Access Compliance Report

Public Rights-of-Way

(Curb Ramps)

Intersection ID: 10032188	Main Street: MORRISON_BV	Cross Street: N/A	Location: NW
ADA ID: A491AD569027	Ramp Type: Perp	Initial Pass/Fail: Fail	Overall Compliance: No
Severity Score: 47.5			
Codes/Mitigation Info/Possible Solution		Field Measurements/Component Compliance

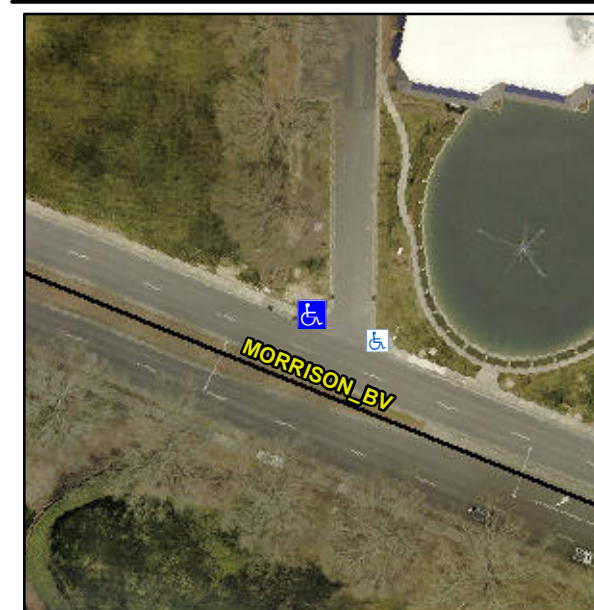
Not Found, R304.5.1, R304.2.2

Compliance	Description	Data	Compliance	Description	Data
N/A	Ramp Length (in)	48.0	No	Ramp Slope (%)	9.2
No	Ramp Width (in)	29.0	Yes	Ramp XSlope (%)	0.9
N/A	Flare Type LT	N/A	N/A	Flare Type RT	N/A
N/A	Flare Slope LT (%)	N/A	N/A	Flare Slope RT (%)	N/A
N/A	Flare Traversable LT?	N/A	N/A	Flare Traversable RT?	N/A
N/A	Landing Length (in)	N/A	N/A	DWS Provided?	N/A
N/A	Landing Width (in)	N/A	N/A	DWS Contrast?	N/A
N/A	Landing Slope (%)	N/A	N/A	DWS Length (in)	N/A
N/A	Landing X Slope (%)	N/A	N/A	DWS Full Width?	N/A
N/A	Landing Curb? (Y/N)	N/A	N/A	DWS Offset (in)	N/A
N/A	Shared Landing?	N/A			
N/A	Gutter Ponding?	N/A	N/A	Gutter Slope (%)	N/A
N/A	Gutter Lip Ht (in)	N/A	N/A	Gutter X Slope (%)	N/A
N/A	Painted X Walk1?	No	N/A	Painted X Walk2?	N/A
	X Walk 1 Direction	To SE		X Walk 2 Direction	N/A
N/A	X Walk 1 Width (in)	N/A	N/A	X Walk 2 Width (in)	N/A
	X Walk 1 Slope (%)	5.6		X Walk 2 Slope (%)	N/A
	X Walk 1 X Slope (%)	1.7		X Walk 2 X Slope (%)	N/A

Remove & Replace Entire Ramp.
